# Access Compliance Report

## Public Rights-of-Way

### (Curb Ramps)

Intersection ID: 10034319	Main Street: PERIMETER_PY	Cross Street: N/A	Location: SE
ADA ID: 2A5A1D4D5C6F	Ramp Type: PerpDiag	Initial Pass/Fail: Fail	Overall Compliance: No
		Severity Score: 37.5

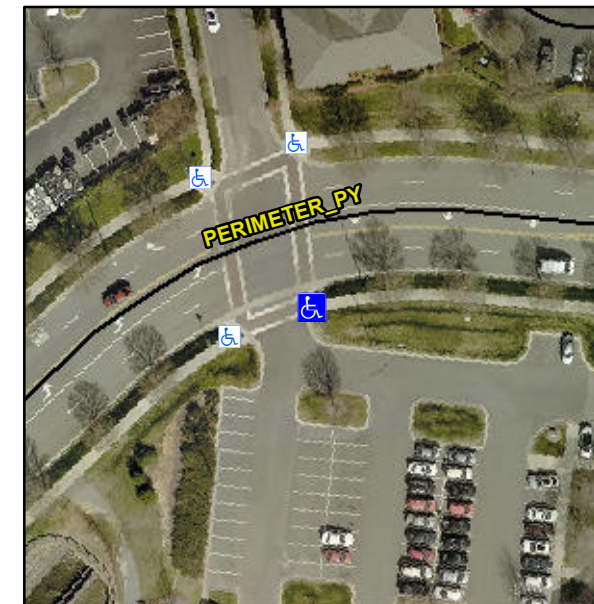
**Remove & Replace Curb Ramp With Two New Directional Ramps or Equivalent.**

**Not Found, R304.2.2, R304.5.3**
